Third Party Planning Objection Report in respect of South Dublin County Council planning application, reg. ref SD22A/0035. The proposed development comprises of (a) Construction of a 4 storey nursing home building consisting of: (i) 106 bedrooms (with ensuite); (ii) associated residents welfare facilities; (iii) administration areas and staff facilities; (iv) multi-function space and pharmacy proposed at ground level; (b) construction of 60 one bed independent living units in 3 blocks as follows: (1) Block A, a 4 storey building comprising 11 one-bed units; (2) Block B, a part 4/part 5 storey building comprising 35 one-bed units; and (3) Block C, a 5 storey building comprising 14 one-bed unit. Each unit will be provided with a private open space in the form of a balcony terrace (6sq.m.) (c) The development will include communal open space and landscaping (including new tree planting and tree retention), 30 car park spaces (including 3 limited mobility parking spaces; 3 EV parking and 1 car sharing spaces); and 52 bicycle parking spaces (d) The development will be served by a new pedestrian and vehicular access from Old Greenhills Road through existing boundary wall (etc.) at Lands

Fig. 21: The applicant's siting of 3 no. buildings along Old Greenhills Road with another block behind

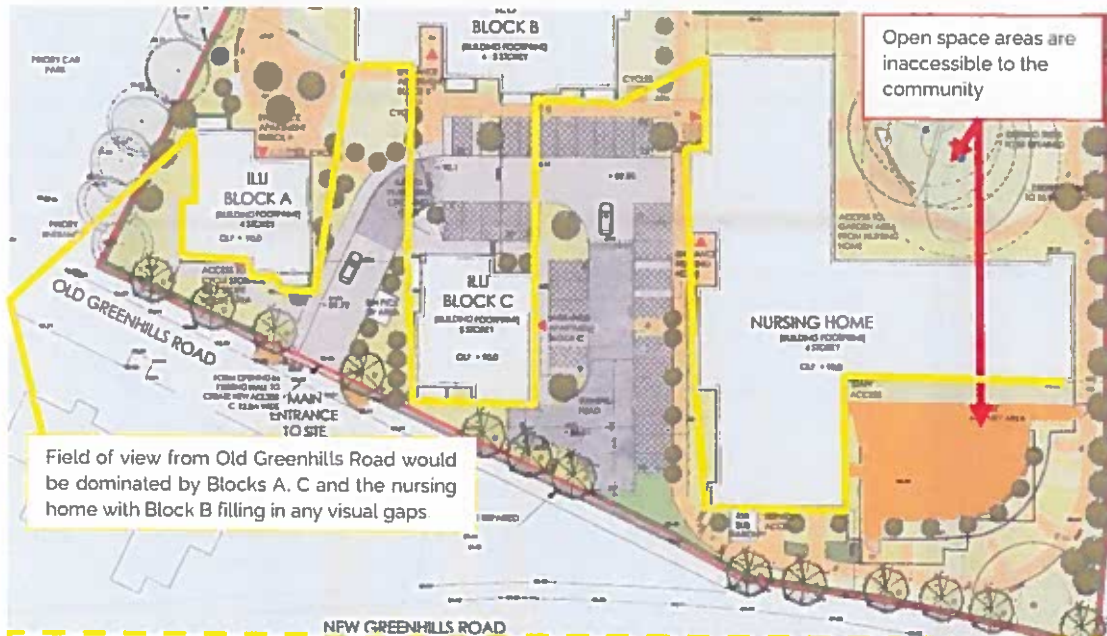
Tallaght Community Council considers that the site of Block A should be a publicly accessible area of open space. A pocket park for the community. The areas of open space to the north of the site are not publicly accessible. This requires the full removal of Block A which would, in any case, cause negative visual and visual overbearing impacts onto Old Greenhills Road.

Tallaght Community Council considers that a new building line shown in dashed blue line should be required. This would mean setting back Block C and re-designing the end of the nursing home. If Block A is retained, it should be setback.

Fig. 23 The siting of Block A within an area of the site which should be a public open space

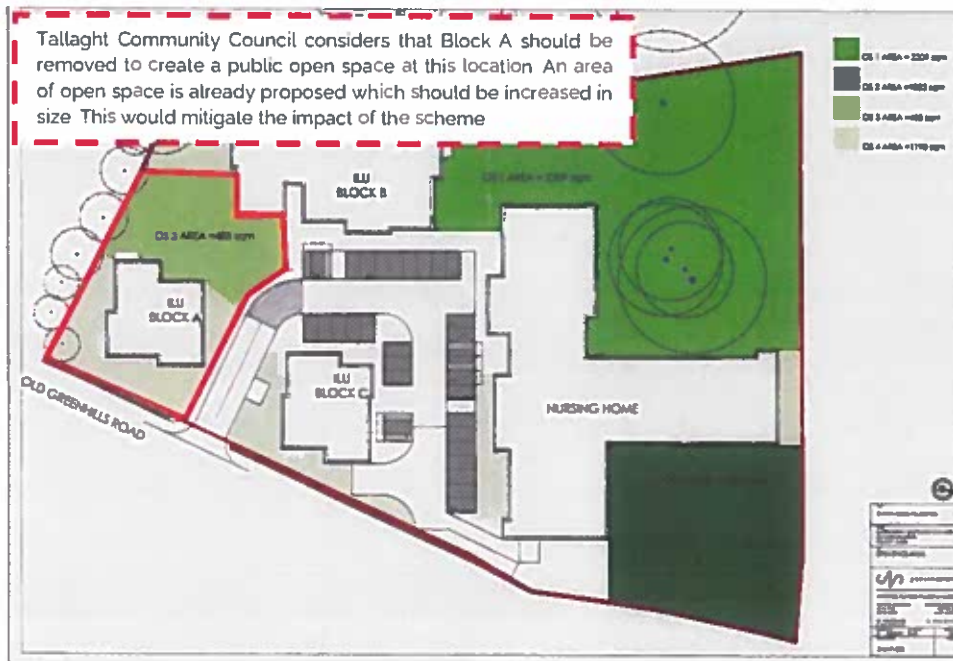
However, in developing this site, the Applicant should be required to provide public open space. The open space provided within this scheme is not publicly accessible. Indeed, Block A is sited and designed such that it marks the entrance to what would appear as a very private development. Tallaght Community Council considers that Block A should be removed in its entirety and replaced with a public park accessed from Old Greenhills Road which can be used by both residents of the scheme and residents of the area.

Fig. 28: Existing trees and RPAs adjoining the area in which Block A is proposed to be sited

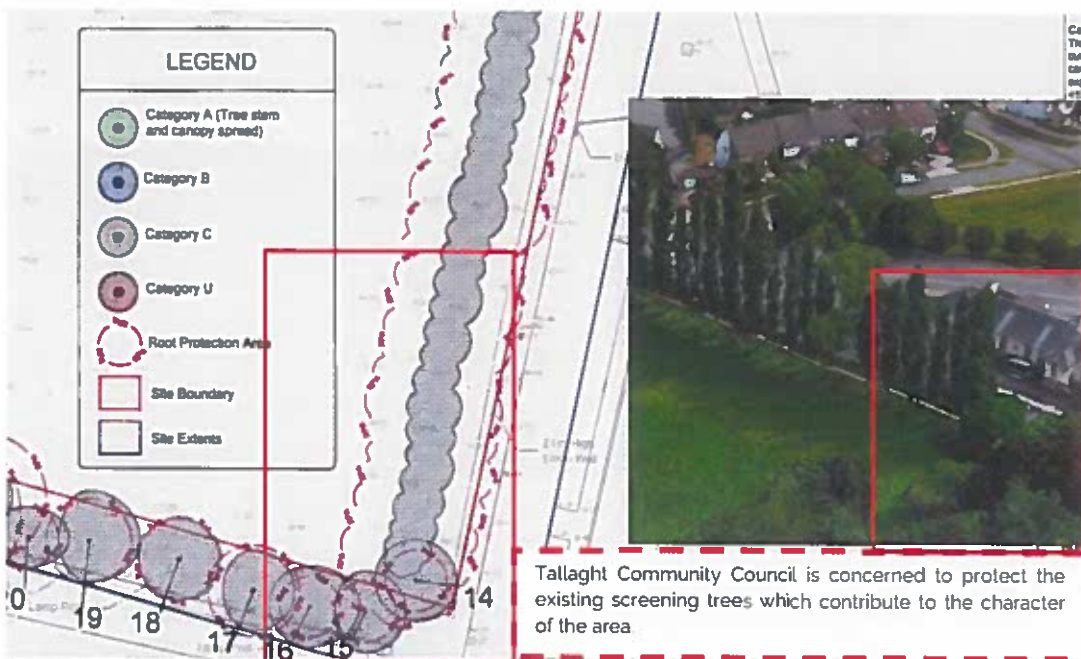
This is not the case. The Applicant proposes the removal of this line of trees and the retention of only several low height trees. Excerpts from the Arborist's drawings are provided in Figs. 28 and 29. Block A's east and south elevations would not be screened by existing trees. The submitted Landscape Plan includes the small number of trees to be retained and proposed a small number of new trees be planted in the setback area from Block A to Old Greenhills Road and The Priority entrance. This minimal planting will offer no adequate screening of Block A.

Fig. 31: The siting of Block C alongside Old Greenhills Road

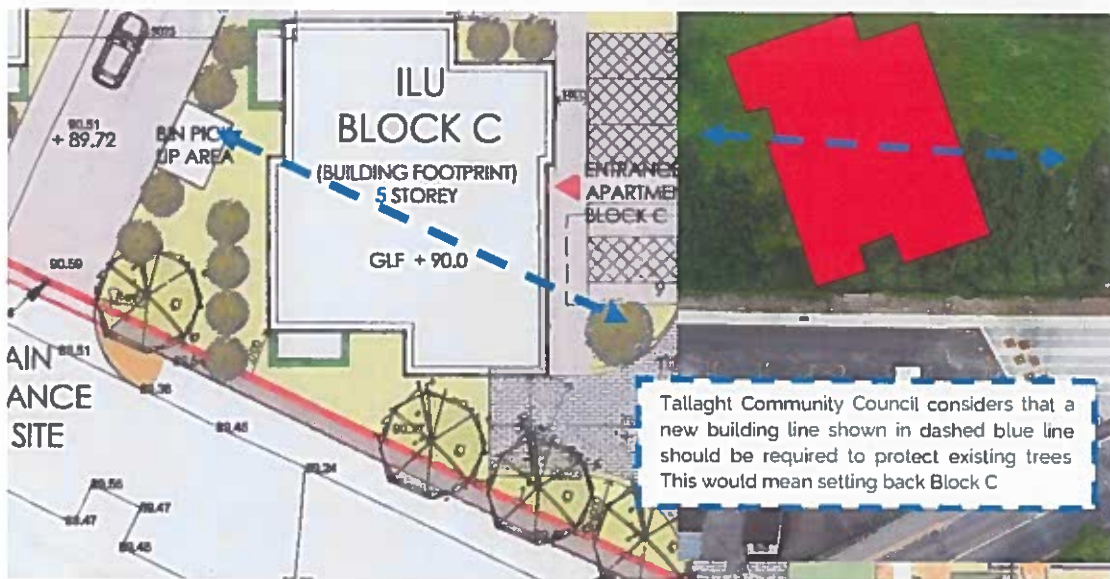
Tallaght Community Council is not asking for the removal of this block as the group considers that it is not unreasonable for this site to be developed and the previous block sited at this location under the last planning application has been broken up. However, Block C is too tall and over-scaled relative to Old Greenhills Road and revisions are required. At minimum, the closest half of the building to Old Greenhills Road needs to be reduced to 3 storeys.

Fig. 46: The siting of Block B relative to The Priory protected structure

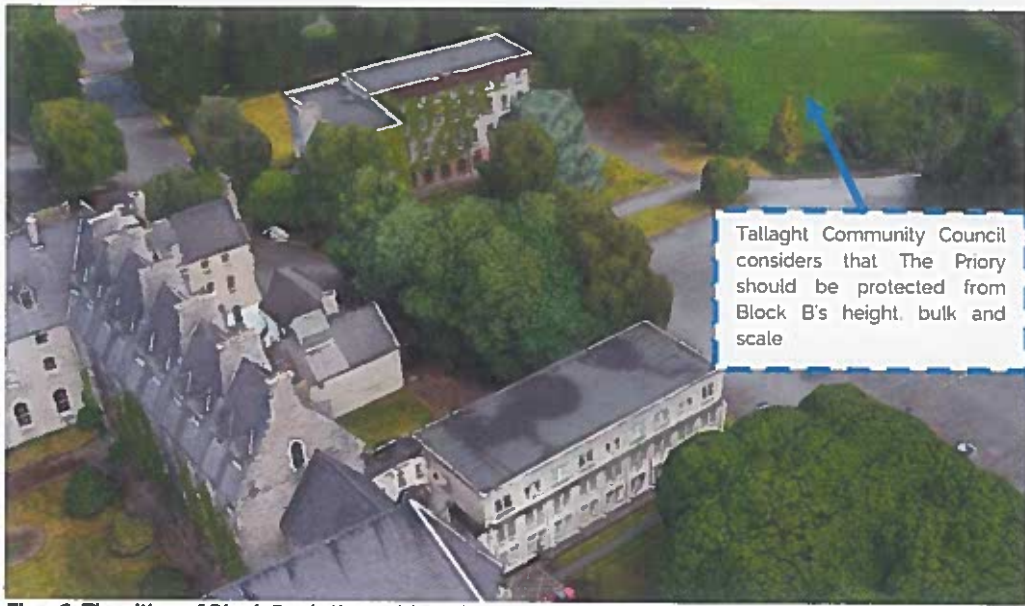
It is the informed opinion of Tallaght Community Council that Block B needs to be broken into two buildings and these should be 3 storeys relative to The Priory and its access driveway. The building should read as subservient to The Priory buildings. As submitted, Block B would have a negative visual impact on The Priory, would detract from the setting and driveway of The Priory and would set a poor precedent for development within these and other protected structure lands in the SDCC area.

Fig. 49: The proposed development within the Zone of Visibility from St. Basil's protected structure

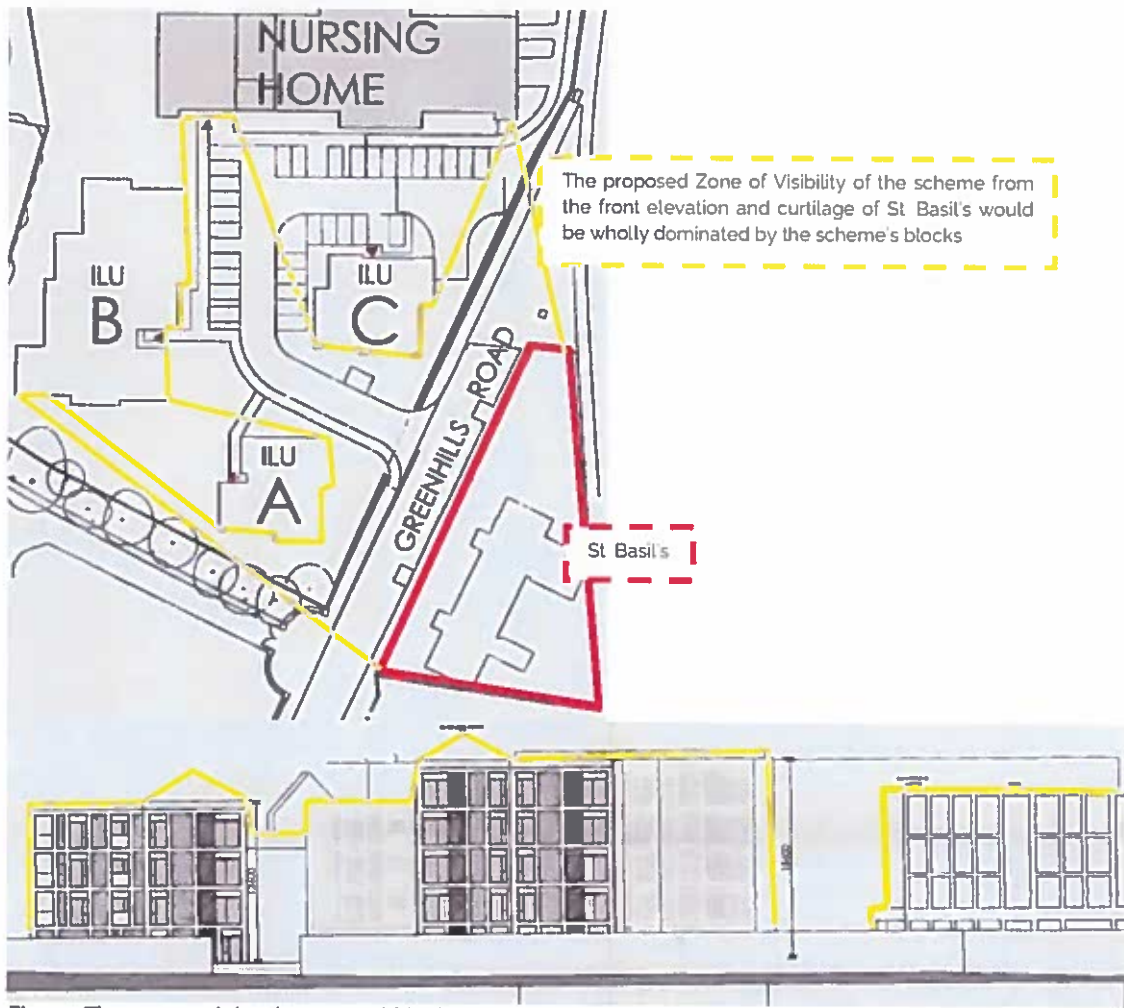
The blocks opposite St. Basil's need to be reduced to 3 and 4 storeys. The 4th storeys should be setback. The buildings themselves each need to be setback at least 15m from the eastern site boundary.

Fig. 54: Contiguous elevation showing a non-existent building

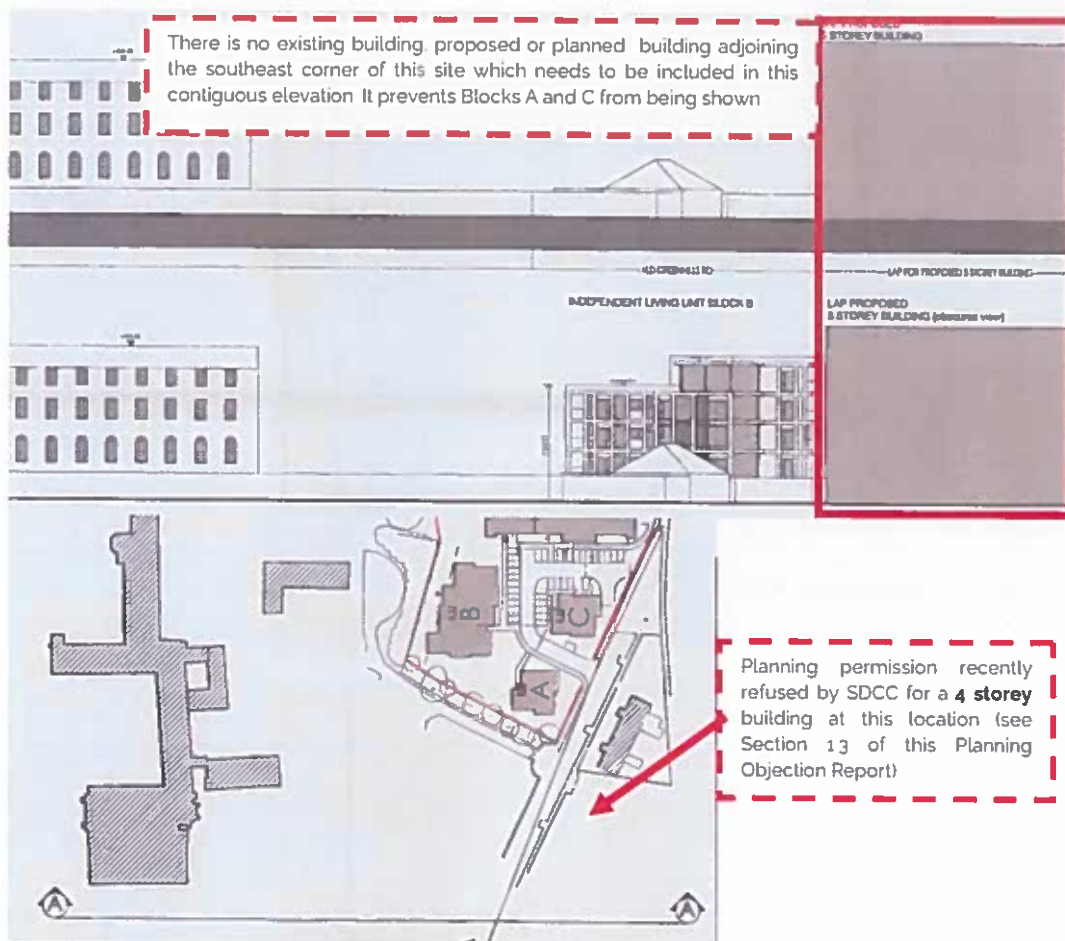
The Applicant should be required to provide a contiguous elevation taken from the south which only shows existing buildings and the proposed development.

Fig. 59: The existing trees appear to be shown on the submitted 'Historic Site Location Map'

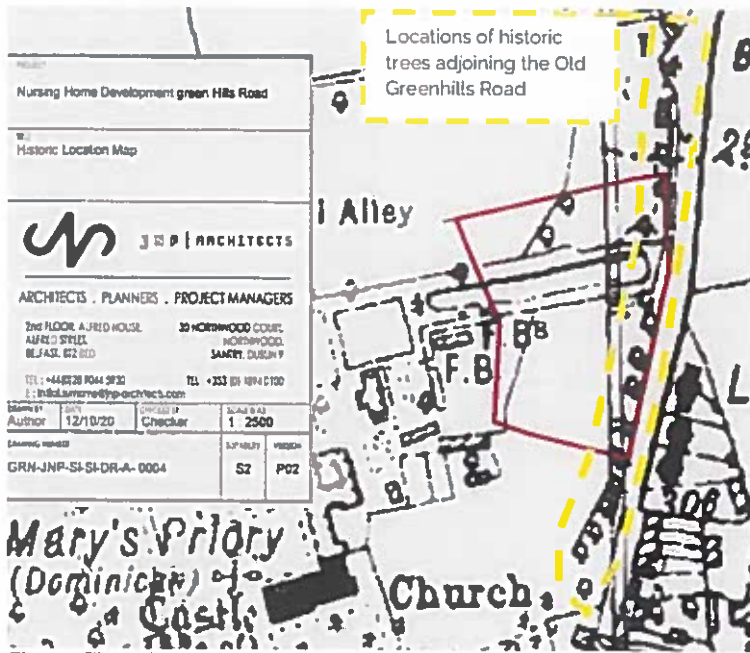
Our client is concerned to protect the established character and pattern of development of the Old Greenhills Road is respectful and sympathetic to the road. This means retaining the mature trees that line the inside of the Applicant site boundary shared with the Old Greenhills Road. There have always been trees at this location historically – trees appear to feature at this location on the submitted 'Historic Site Location Map' (see Fig 59).

Fig. 65: The removal of the existing Poplar trees would make a "significant" difference

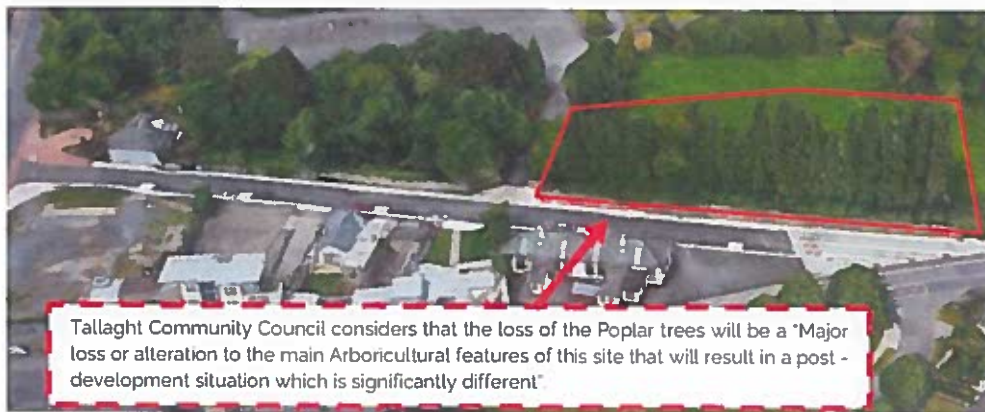
Tallaght Community Council considers that the loss of the Poplar trees will be a "Major loss or alteration to the main Arboricultural features of this site that will result in a post-development situation which is significantly different".

Fig. 67: The proposed mitigation for the loss of 23 x 20m tall Poplar trees is 13 young columnar trees

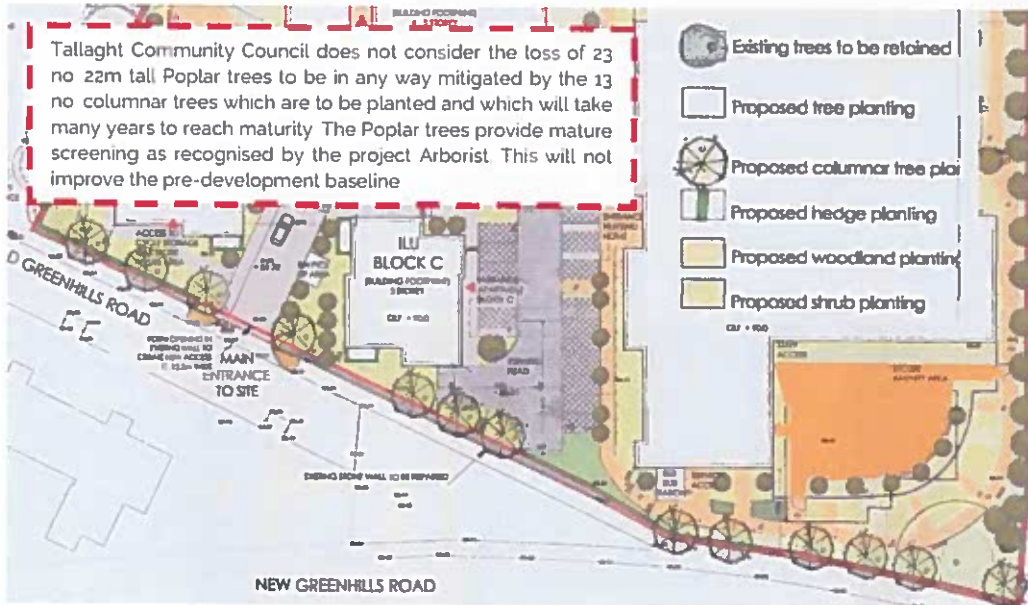
Tallaght Community Council does not consider the loss of 23 no. 22m tall Poplar trees to be in any way mitigated by the 13 no columnar trees which are to be planted and which will take many years to reach maturity. The Poplar trees provide mature screening as recognised by the project Arborist. This will not improve the pre-development baseline.

Fig. 77: The proposed vehicular entrance should be refused in favour of the use of The Priory entrance

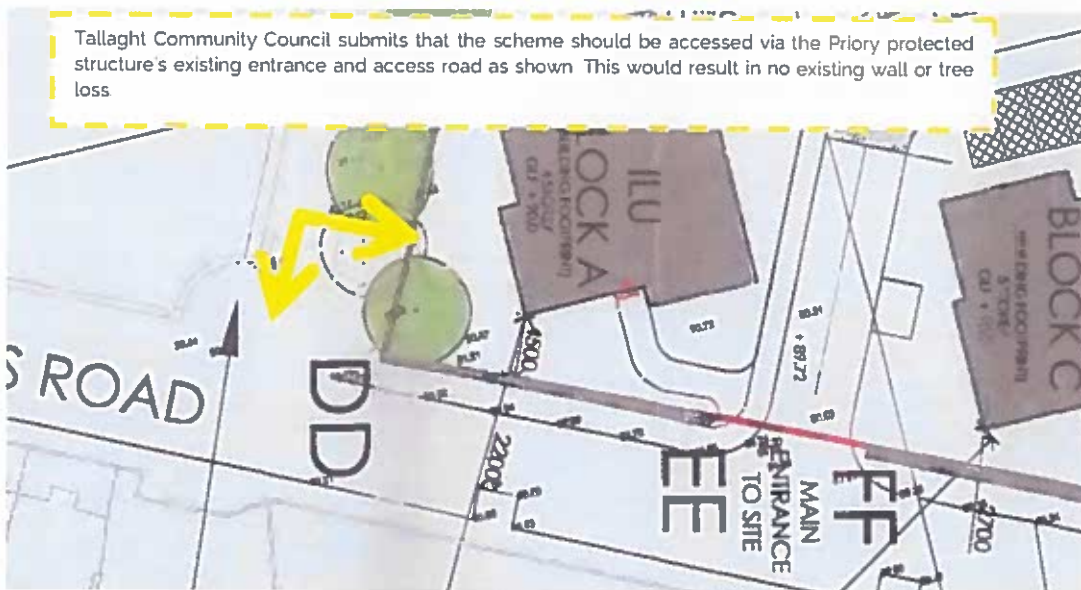
Our client considers that the proposed entrance should be refused in favour of an internal entrance off The Priory protected structure's internal access road. This would result in no existing wall (see Fig. 77). The Applicant has known about this concern since the last refused application and has not addressed it despite repeatedly arguing that this is a "campus style development" which will add buildings to the existing Priory. Why then can they not share an entrance and driveway?

Fig. 78: The proposed vehicular entrance would cause the loss of on street car parking

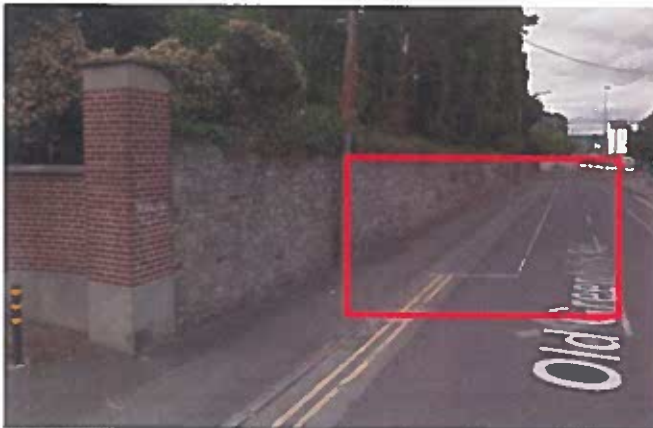
Our client notes how the proposed entrance would cause the loss of on road car parking (see Fig. 78) As the scheme is offering minimal parking spaces at a rate well below CDP standards, our client submits that the result of this proposal will be overflow car parking but the loss of on road car parking will mean fewer places for these vehicles to park.

Fig. 81: The proposed bin collection area is unnecessarily visible from the Old Greenhills Rd

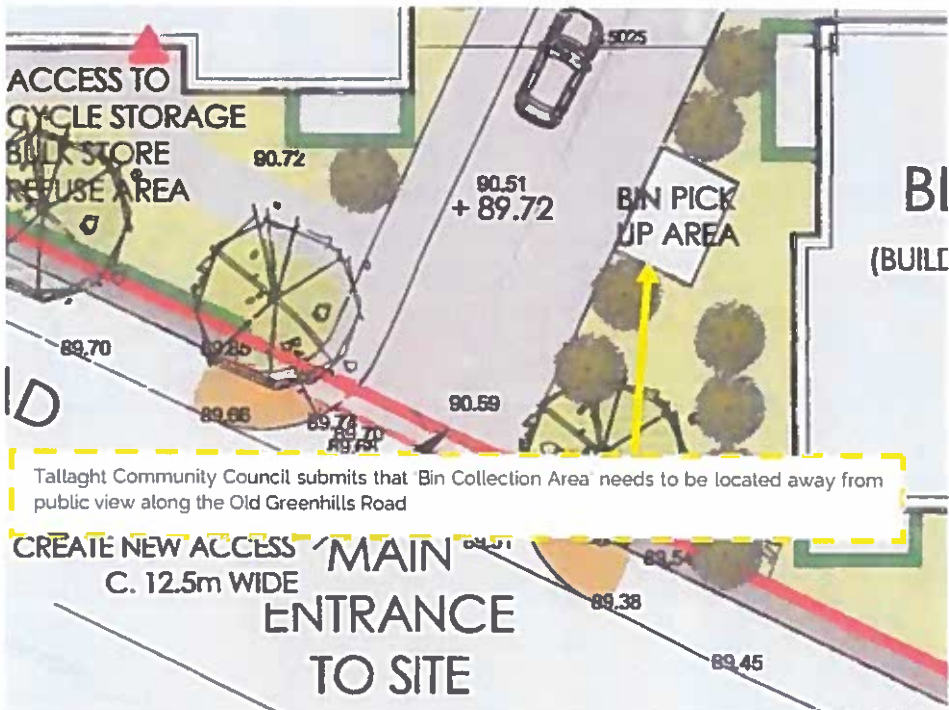
Our client can see no reason why the proposed 'Bin Collection Area' needs to be sited in a manner which would make it visible from the Old Greenhills Road. This area should be relocated. In the event of the scheme entrance being re-located - as proposed in this Planning Objection Report - then this area could be placed beside the ESB Substation where it is located behind a 2m tall wall and retained existing mature trees. The concurrent planning application across Old Greenhills Road also includes a bin store visible from the road - public realm issues need further consideration in both applications.
